**Observation on Strategic Housing Application by Cairn Homes Properties Limited:
Demolition of 'Winterbrook', and the former dwelling attached to Barrington Tower (a
protected structure), construction of 534 no. Build to Rent apartments, creche and
associated site works. Address of development: "Barrington Tower", Brennanstown Road,
Dublin 18. (ABP Ref. 313281)**

Proposed Strategic Housing Development at Barrington Tower, Brennanstown Road – Transport Submission

Contract Number	C841 2022
Topic	Transport Submission in Relation to Development at Barrington Tower, Brennanstown Road (ABP Ref. TA06D.313281)
Version Number	v1.5
Status	Final
Author	Eoin Munn, Sean Byron
Reviewer	Eoin Munn
Date	12 May 2022

Figure 2: Extract from the Applicants TTA with additional annotation.

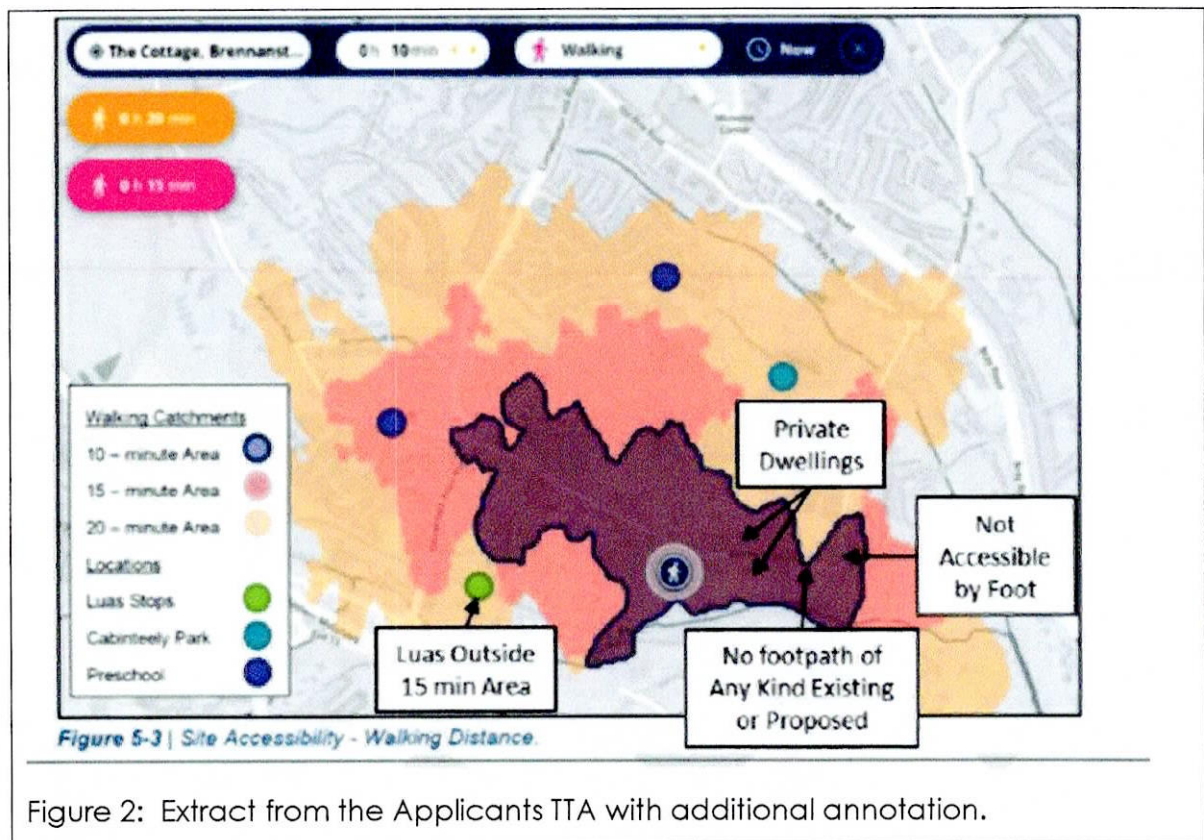
4. Insofar as is also stated that the Carrickmines Luas stop and the Laughanstown Luas stops are a c. 13 minute and 15 minutes' walk from the site I note the nearest Luas stop (Carrickmines) appears to be more than a 1.5 kilometre walk from some parts of the site (see the attached report by Transport Insights) and contrary to what is stated in Planning Report (13 minute walking distance from the site to Carrickmines Luas stop) Figure 5.3 of the Applicant's own TTA shows that Carrickmines Luas stop is in excess of a 15 minute walk from the application site (annotated extract from the TTA below).

Figure 3.2 Applicant's Site Accessibility Assessment*

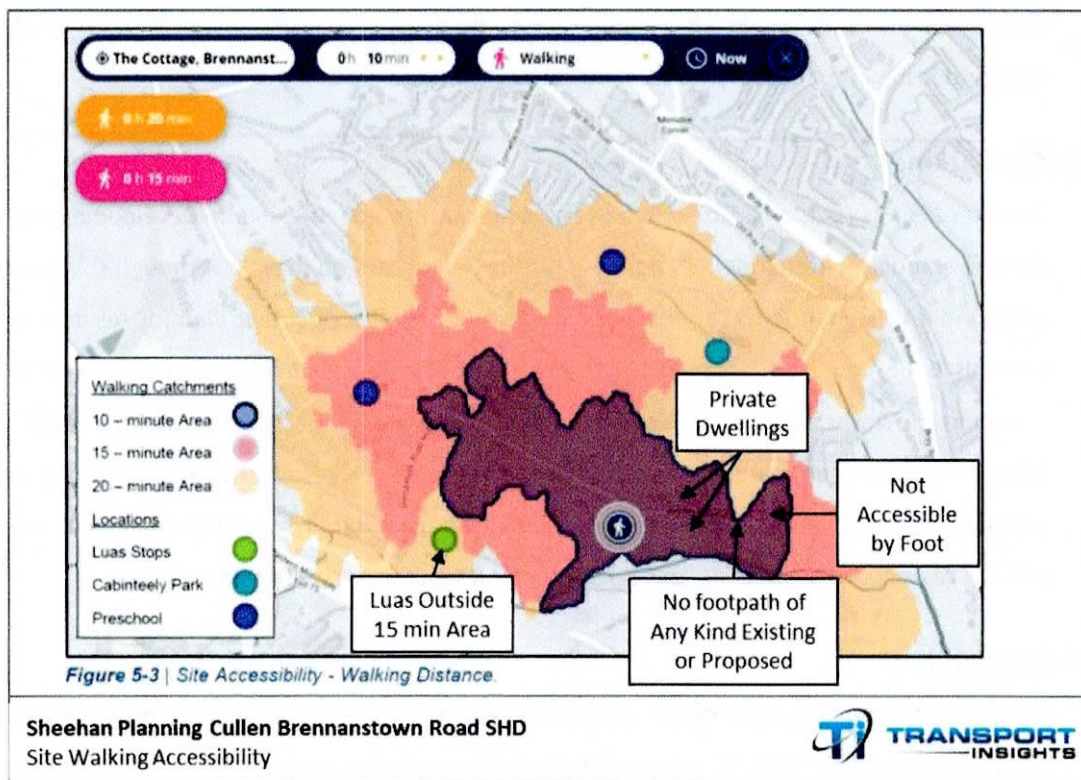
As can be seen from the preceding Figure 3.2, the applicant illustrates walking routes along areas where no footpaths exist and also within private dwellings with no access to the public. Furthermore, by the applicant's own assessment, the Luas Stop at Carrickmines falls within the "20 – minute Area" i.e. is not considered within the catchment of the site.
